TITLE: **HP810 LEFT PCB**

ORG DRAWN: TAZ	DATED: 5/27/04	CODE: D	SIZE: D	DRAWING NO: 76D5473	REV: 01
CUR REV DRAWN:	DATED:	DRAWING NO: HPOPLMN1.SCH		FILE NAME:	
RELEASED:	DATED:	SCALE:		SHEET: 1 OF 2

REVISION RECORD					
REV LEVEL	ASMBLY LEVEL	DATE	ECO	ENG.	DESCRIPTION
A	A	9/03		TAZ	PROTOTYPE PCB
B	A	10/29/03		TAZ	PCB REVISION FROM A TO B MOVED ALL SWITCHES UP BY 0.060" TO USE NEW SWITCH CAPS SO AS SAME HEIGHT AS SWITCHES ON INPUT MODULES - INTERNAL WORKING LEVEL CHANGE FROM +4dBu TO -2dBu CHANGE R74 FROM 30.1K TO 16K2 CHANGE R109 FROM 33K2 TO 18K25 CHANGE R87, R105 FROM 10K7 TO 20K CHANGE R49, R201 FROM 10K TO 20K CHANGE C7 FROM 100pF TO 39 pF CHANGE R125, R126, R136, R135 FROM 30.1K TO 15K CHANGE R127 FROM 15K TO 7K5 CHANGE R112, R114 FROM 4K99 TO 10K CHANGE R123, R124 FROM 5K62 TO 10.7K - MUTE TRIM CHANGE R118 FROM 499R TO 187R - REMOVE CLITCH THAT OCCURRS WHEN SOLO SWITCH RELEASED - ADD C91 AND C93 (100nF) - CHANGE STEREO RETURN MID EQ TO PEAKING AT 2KHz CHANGE C1, C9 FROM 5N6 TO 10N CHANGE C2, C8 FROM 2N2 TO 3N9 - CORRECT ERROR CHANGE R45 FROM 15K TO 10K
00	A	1/16/04		TAZ	PCB REVISION FROM B TO 00 - PRODUCTION RELEASE. MOVED LED UP 0.050" - SITTING LOW ON THE PCB. REMOVED C91

TITLE: **HP810 LEFT PCB**

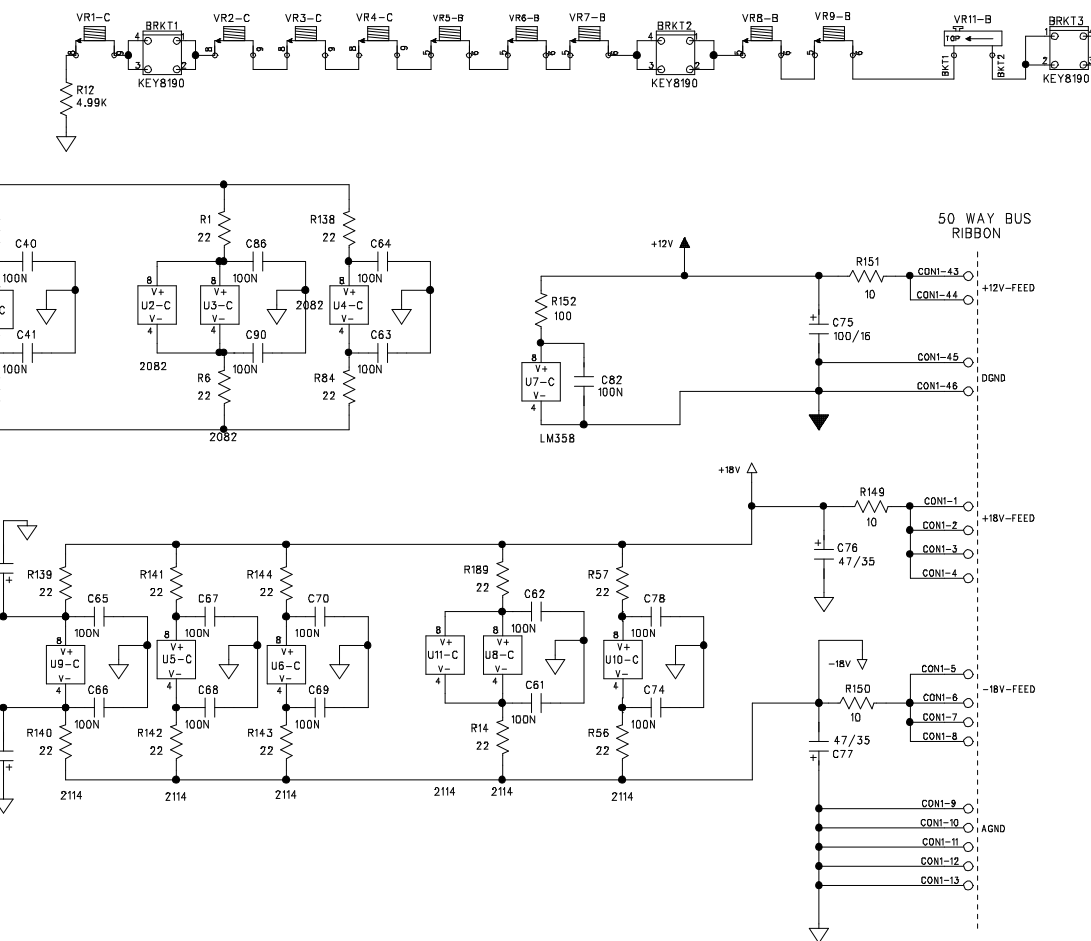
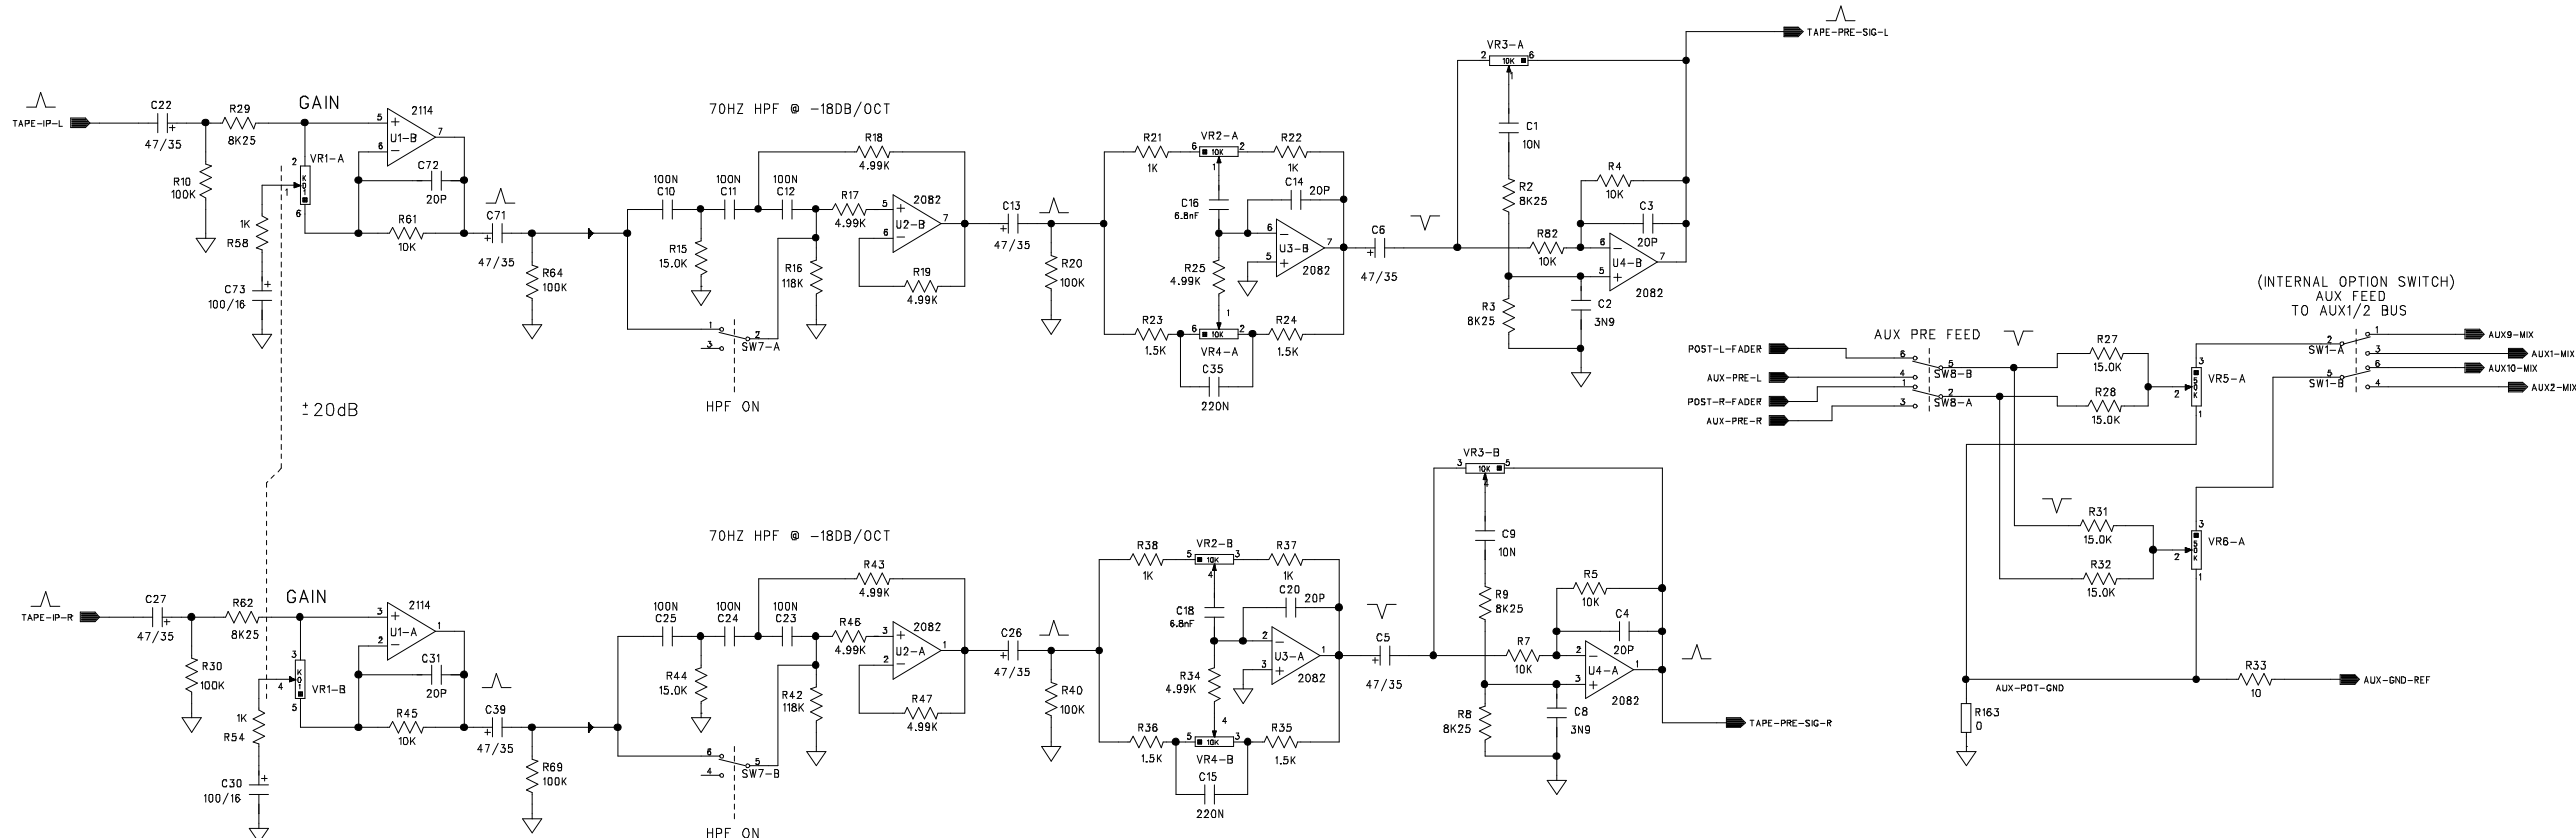
01	A	5/27/04		TAZ	PCB REVISION FROM 00 TO 01 - AUX9/10 SPEC IMPROVE CHANGED TRACKING OF STEREO FEED TO AUX 9/10 (IMPROVE NOISE/XTALK SPEC) CHANGE VR5 AND VR6 FROM DUAL TO SINGLE POT ADDED SW1 (INTERNAL SWITCH FOR OPTION SELECT)
